VILLAGE OF TUSCARAWAS
TUSCARAWAS COUNTY, OHIO

CHERRY ST WATER LINE REPLACEMENT & STORM SEWER IMPROVEMENTS

ADDENDUM #1

THRASHER PROJECT #T10-11077

SHEET No.
7

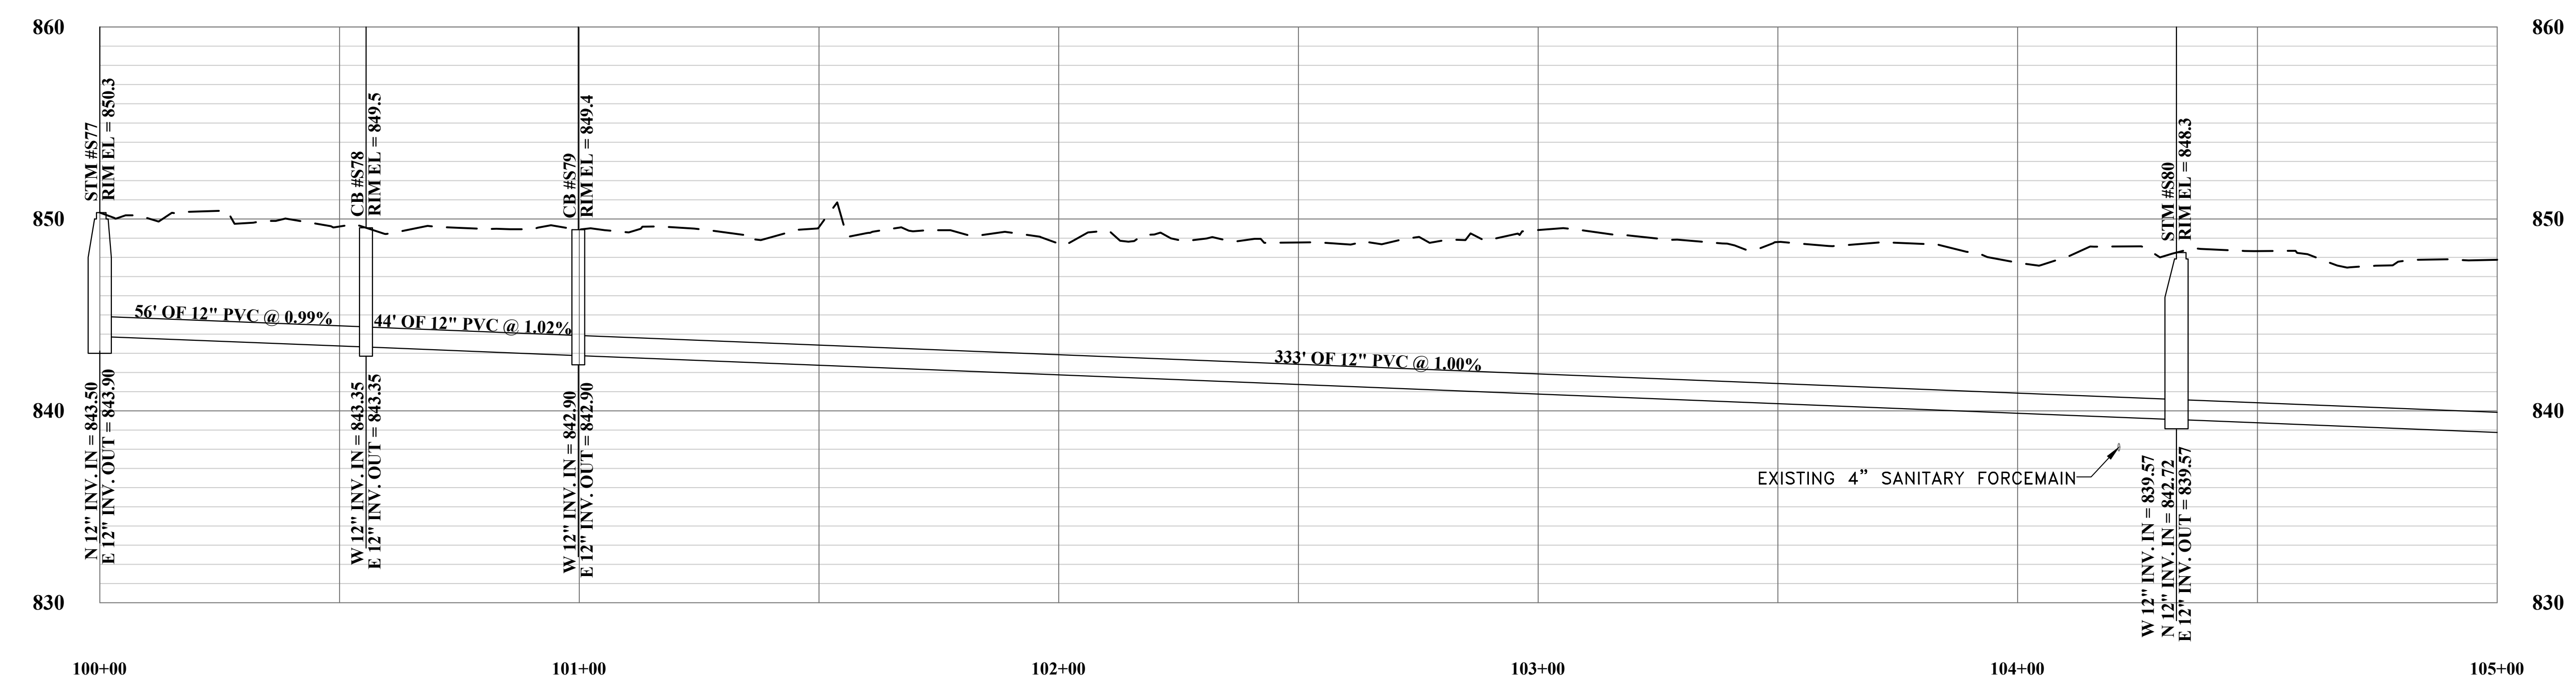
8. QUESTION

Can you provide the elevations for RIM and INVERT on CB# S75 and CB# S84?

RESPONSE

See attached Sheets 7 and 7A.

SHEET No.
8

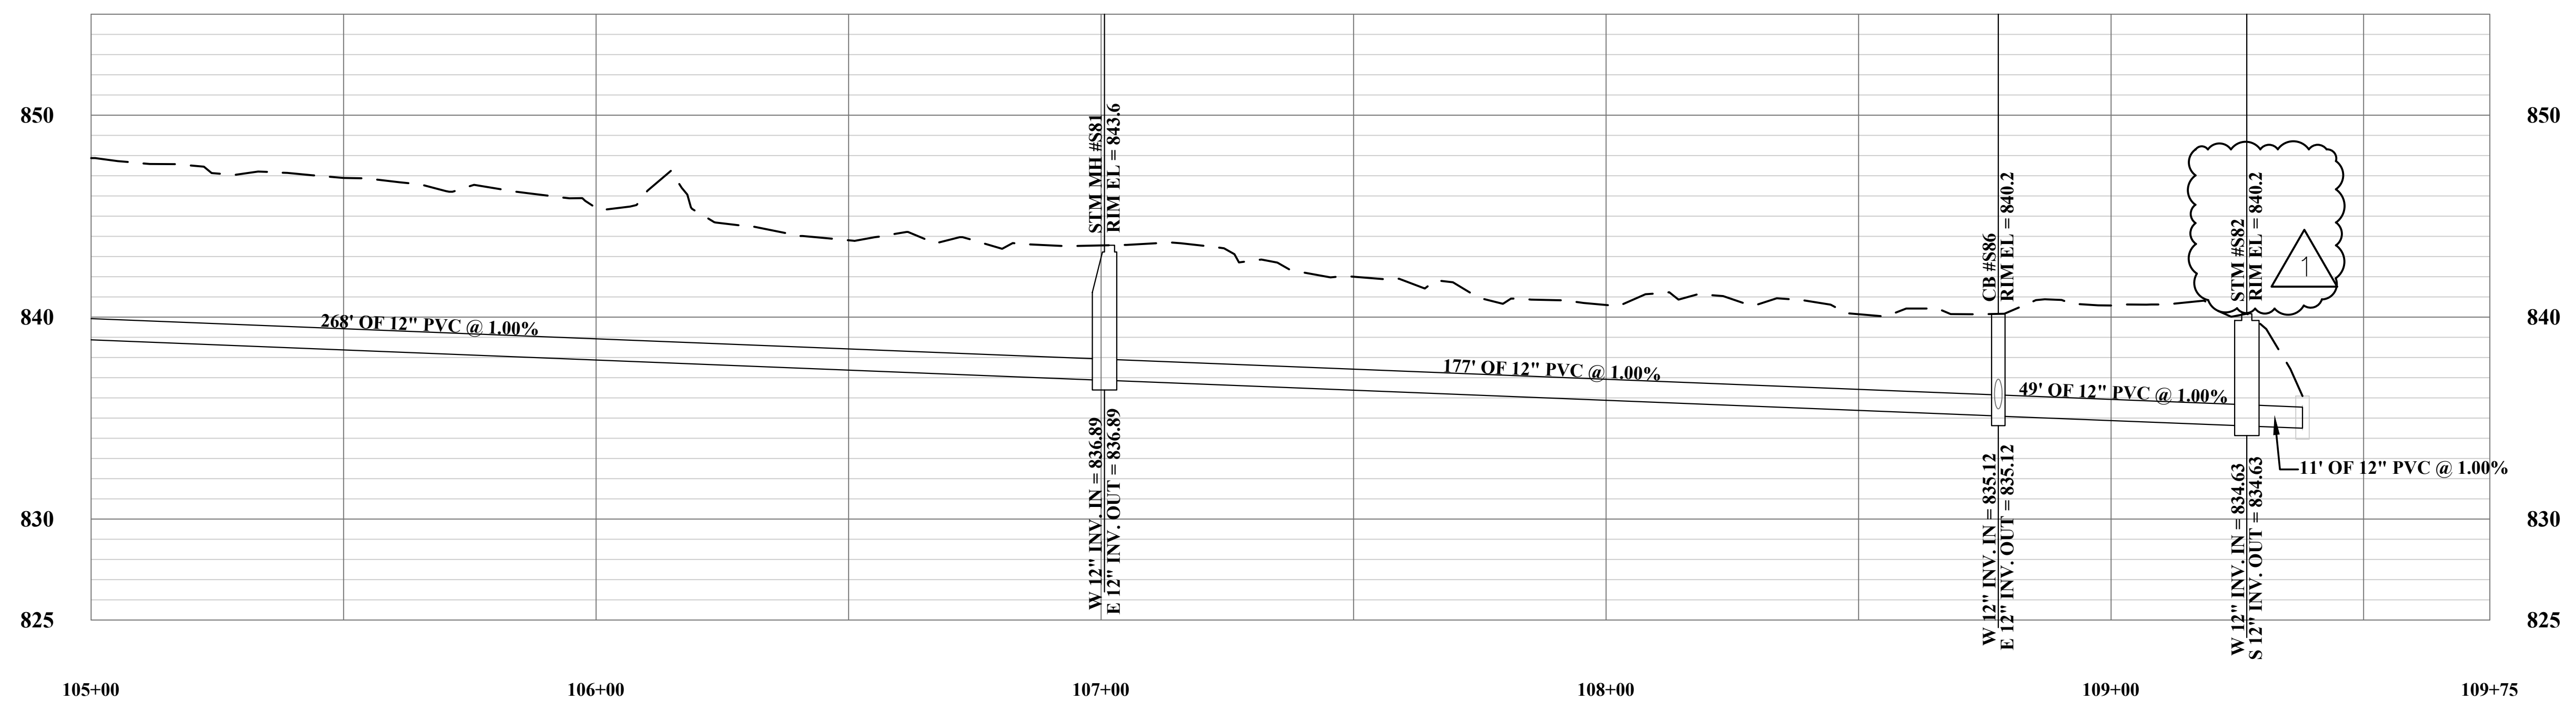
2. QUESTION

Can you tell me what the junction chamber is for this job?

RESPONSE

The junction chamber will be a manhole (48"). The plans have been revised. (See attached Sheet 8)
